**CITY OF NEWPORT BEACH**

**Re: Letter of Appeal for Revision of the Preliminary FIRM and BFE for the City of Newport Beach  
Community No.: 060227  
Case No.: 12-09-1324S  
Docket No. FEMA-B-1673**

Figure 19. Proposed Revised VE Zone Extent for Zone 22

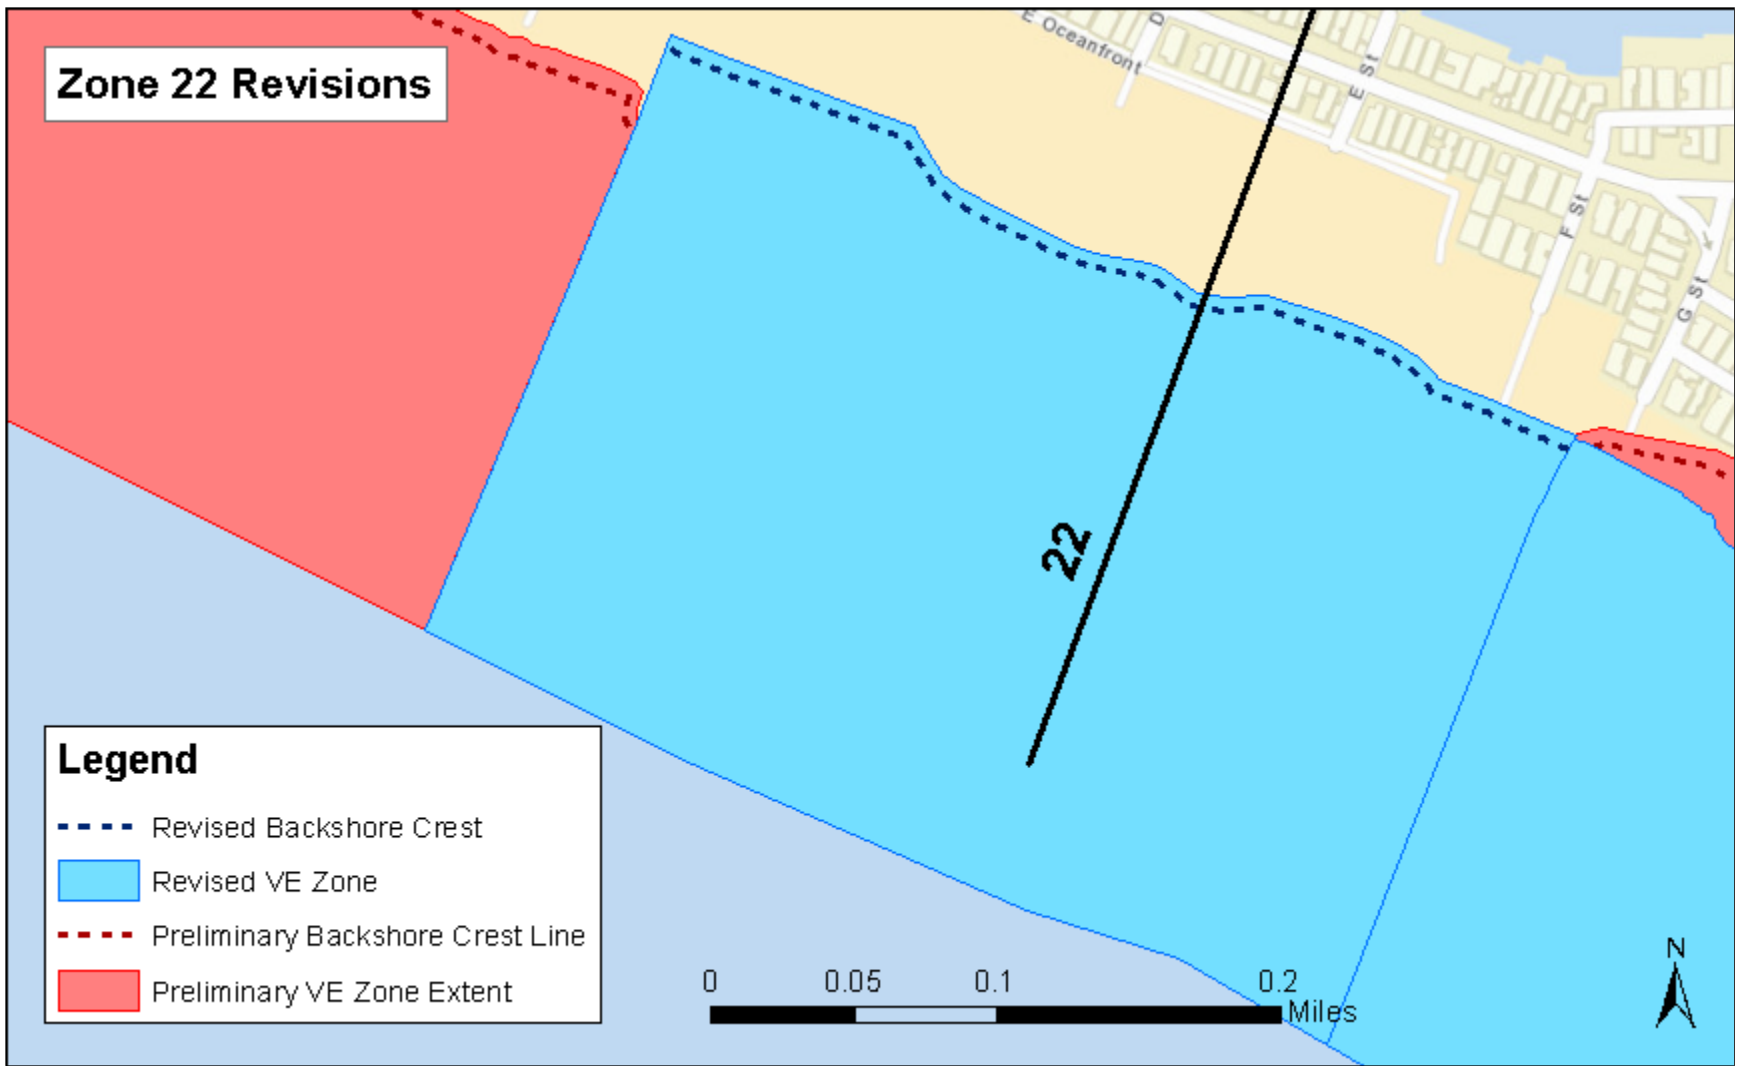
In Zone 22, our calculated 1% TWL is higher than the 1% TWL determined from the OPC Study. In this case, our 1% TWL causes overtopping of the foreshore crest and any apparent backshore features. Therefore, we conducted backshore overtopping analysis in Zone 22; whereas this did not appear to be conducted in the OPC study. Again, we used the approximate location of beach berms to define the backshore feature location. Figure 19 shows the revised versus preliminary VE Zone extent, with the revised results of this study extending slightly further inland compared with the OPC Study results.

1. Revise the FIRM for the AE zone to the proposed revised flood map shown in Figure 9b that was developed based on 2D hydrodynamic modeling, a scientifically accurate method. The FEMA method and assumptions (Bathtub model) are scientifically incorrect.
2. For the VE Zone, revise the BFEs to those shown Table 3. The proposed revised BFEs were developed based on an accurate use of the available beach slope data. In addition, revise the preliminary FIRM for Zone 16, 17, 18, 20, 22, and 23/24 to the proposed revised VE zone extents shown in Figures 15 to 20.

Figure 20. Proposed Revised VE Zone Extent for Zone 23/24

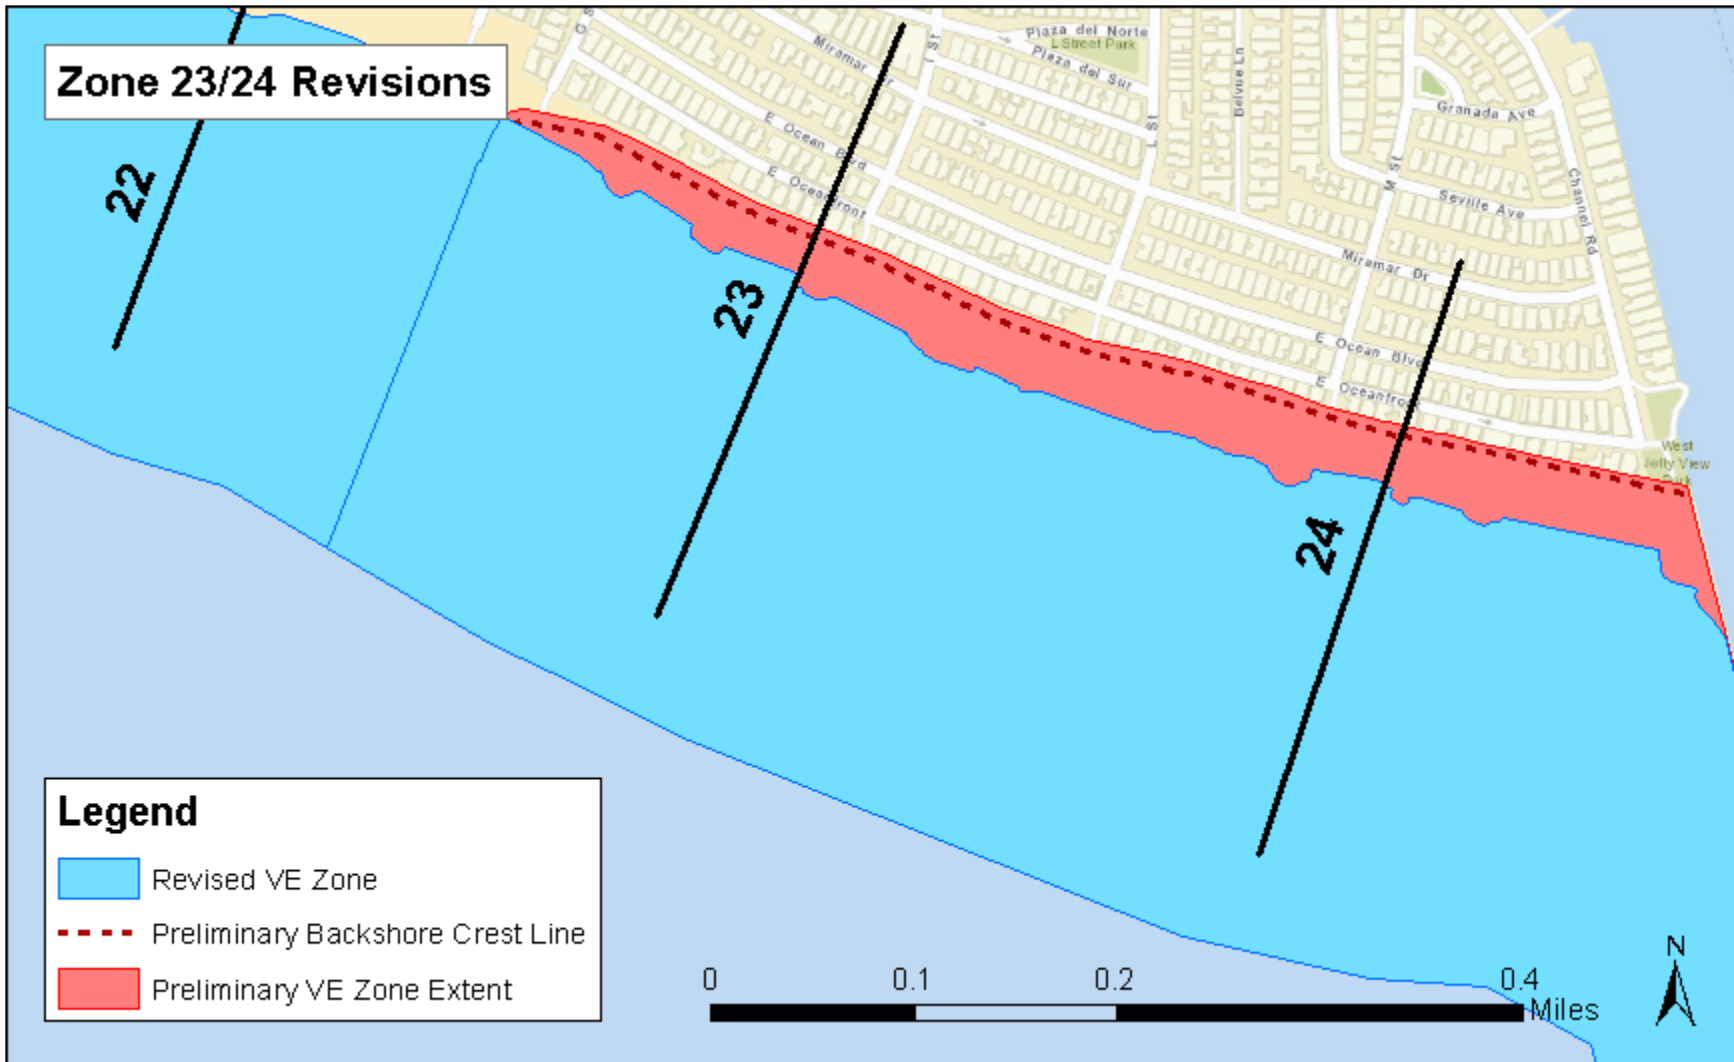
In Zone 23/24, which includes two different transects, the preliminary 1% TWLs overtop the foreshore beach crests and backshore features. However, the revised 1% TWLs do not overtop the backshore dunes in the beach profiles for either transect 23 or 24. This is because the average transect slope within this combined shoreline reach is significantly lower than the transect slopes determined directly at transects 23 and 24 (Figure 11). Since the revised 1% TWLs do not overtop the dunes, the revised VE zone extent is defined as the intersection of the 1% TWLs and the beach dunes. The revised versus preliminary VE Zone extents are compared in Figure 20.
